## **DAYLIGHT + SUNLIGHT ANALYSIS**

**PROPOSED RESIDENTIAL DEVELOPMENT AT THE JUNCTION OF GRANGE ROAD,  
NUTGROVE AVENUE AND LORETO TERRACE, RATHFARNHAM, DUBLIN 14.**

**ADDITIONAL INFORMATION Reg. Ref. SD22A/0126**

Reference Image 2: Ground Floor Plan

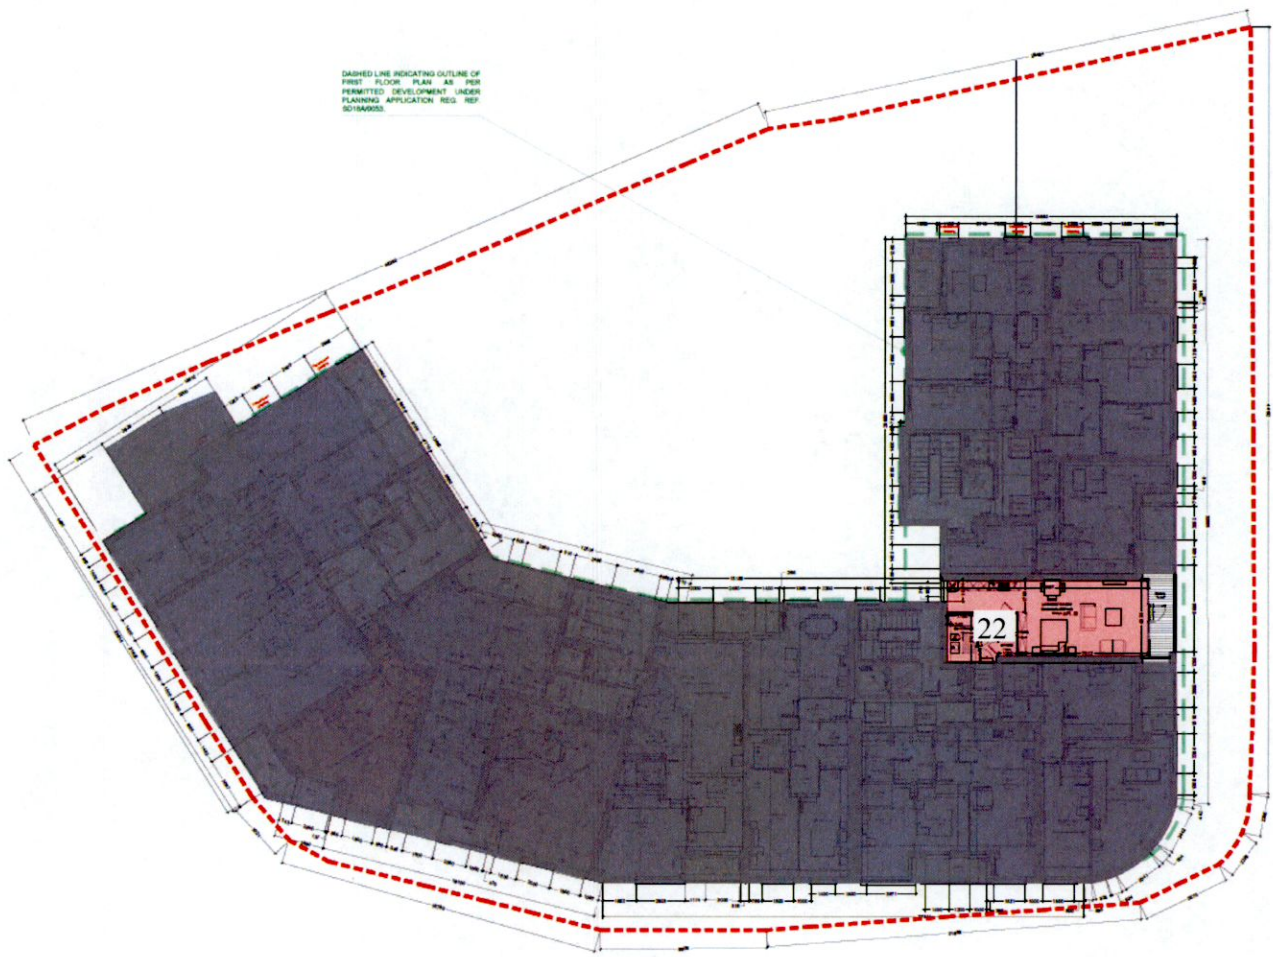
*- A number of single aspect units at ground level appear to be sited under an overhang at first floor. There is concern that the 'no sky line', vertical sky component, and internal light levels, would indicate insufficient lighting to habitable spaces. This applies to units 2, 3, 4, 5, 7, 8, 9, and 10.*

Units 2, 3, 4, 5, 7, 8, 9 & 10 located on the ground floor (see reference image 2) have been carefully assessed for 'no sky line', vertical sky component and internal light levels and the results show that the habitable spaces in these units meet the requirements as per the BRE guide and BS 8206-2 2008 (British Standard Institution, 2008) and the latest guidelines for new apartments as issued by the Department of Housing
